## Earthworks Assessment on Resource Consent Application

Service Request No: 528330

Site Address: **1-23 Tasman St**

# CONSULTANT'S ADVICE NOTE

Figure 2: Cross Section A

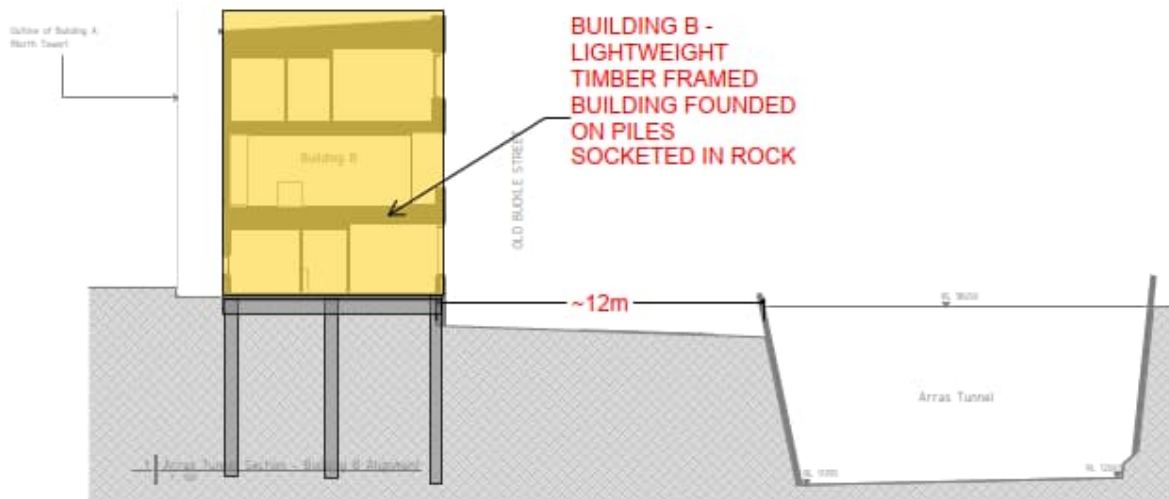
The activities that have been identified to have a potential to cause ground settlement are collapse of pile bore, pile driving, compaction of hardfill, deflections of retaining wall, groundwater drawdown and typical construction vibrations. Settlement (if any) induced by these activities is likely to be local to the activities. Proposed buildings are at least 12m away from the Arras Tunnel and the basement is about 20m away.

Proposed building foundations are at least 12m away from the Arras Tunnel. Accordingly, we consider the ground lateral movement affecting the Arras Tunnel to be less than minor.

Figure 4: Cross Section C

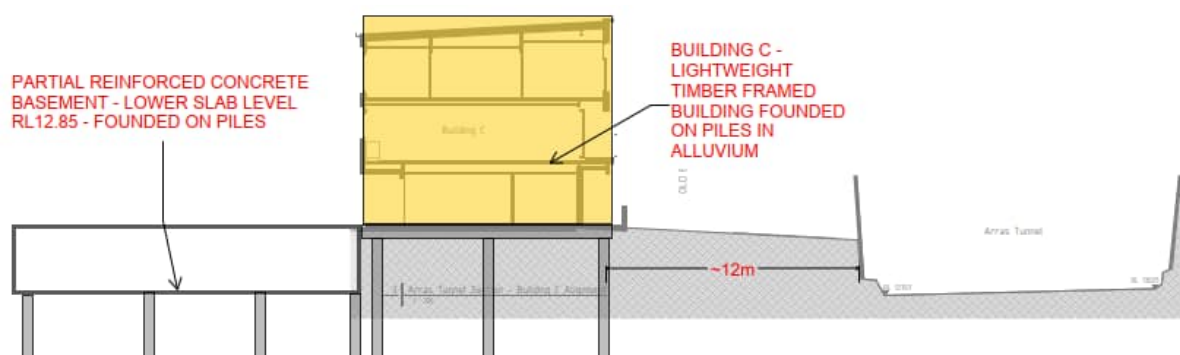
Groundwater level across the site varies between 3.2m and 4m below ground. The lower level of the proposed basement is at a similar level to the carriageway (approx. 12mRL). The lower basement is horizontally separated from the Arras Tunnel portal by approx. 20m. The lower basement carpark is proposed as a "watertight" construction. This means that the basement will not rely on lowering of ground water levels through pumping for its use. Based on this design approach the ground water levels in the proximity of the basement are unlikely to be significantly affected. The proposed construction sequence for the construction of the lower basement is to install a full perimeter sheet-piling or similar system. This will significantly limit the inflow of any groundwater into the excavation.

As per our meeting of 29 March 2023, our understanding is that this item refers to the cut slopes and retaining structures in the proposed development. Retaining structures are likely required to enable the basement excavation but this is about 20m away from the Arras Tunnel. Additionally, the contractor will engage temporary works engineers to design any significant temporary cuts or retaining walls. Nonetheless, there is unlikely to be significant cuts or retaining structures (>1.5m) along the buildings close to Arras Tunnel.
